RE: GRU Comments to GeoTrans' Work Plan entitled *Field Investigation of Historical Linear Features Identified from Aerial Photographs and Potential Drum-Disposal Areas, Koppers Inc. Site, Gainesville, Florida* dated October 11, 2010

GRU & City of Gainesville Comments to GeoTrans' Work Plan entitled: *Field Investigation of Historical Linear Features Identified from Aerial Photographs and Potential Drum-Disposal Areas, Koppers Inc. Site, Gainesville, Florida* dated October 11, 2010

Annotated Aerial Photographs of Former
South Lagoon Area

Koppers South Lagoon 1968

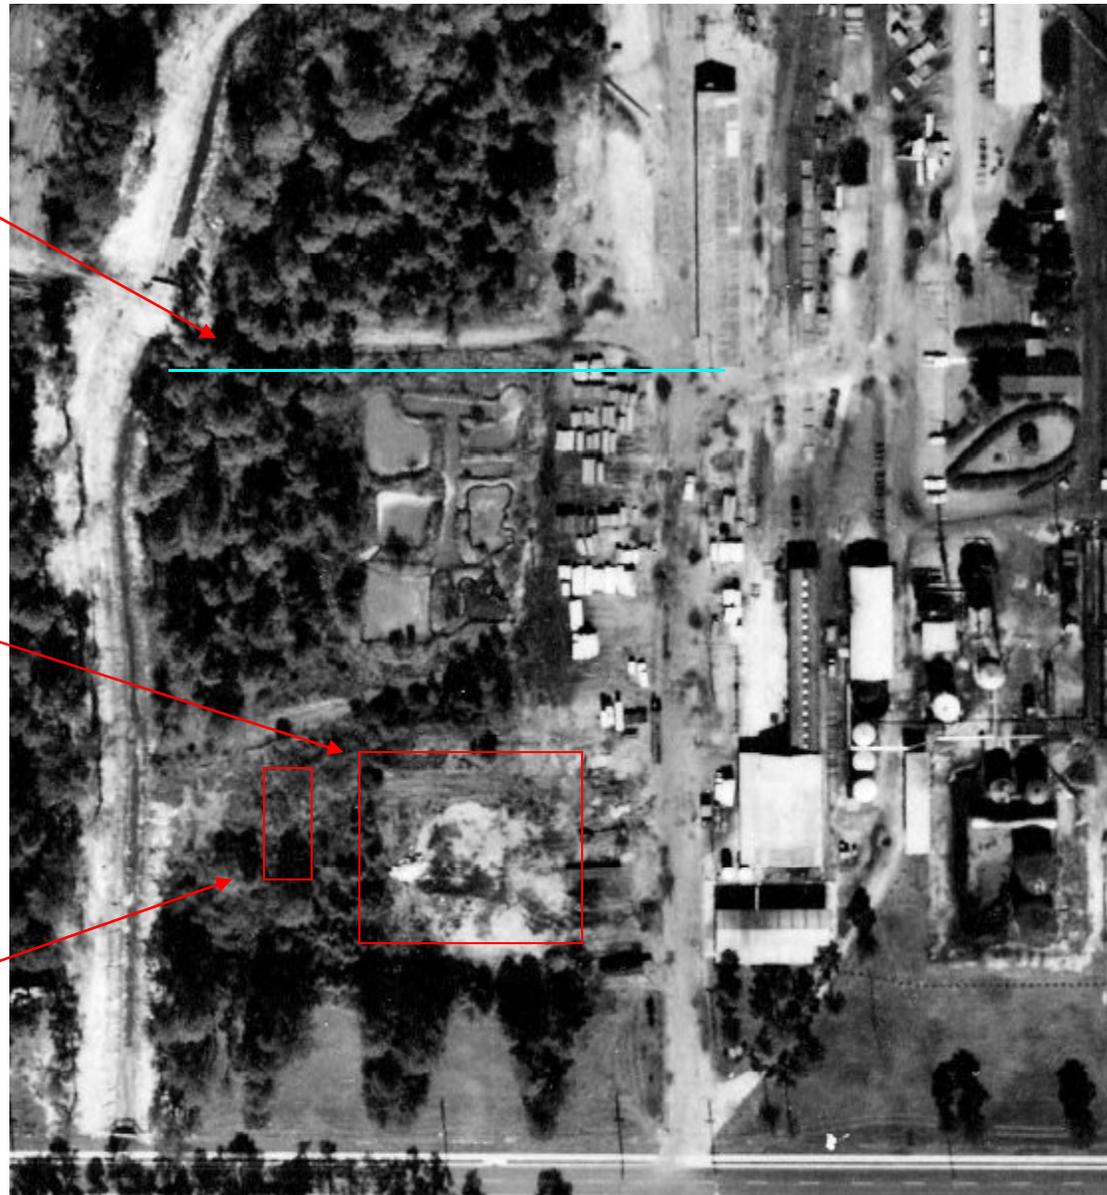
The previously unidentified pond is visible in the 1961 and 1968 aerials and is outside the mapped Former South Lagoon. The pond appears to be west of the area investigated by soil borings and test pits (as reported in the DNAPL Source Zone Evaluation report dated September 2004). See the attached aerial photos^{2,3}. Boring CPT-43S is south of the pond.

**Former pond
west of linear
features.**

**Note difference
between pond
and shadows.**
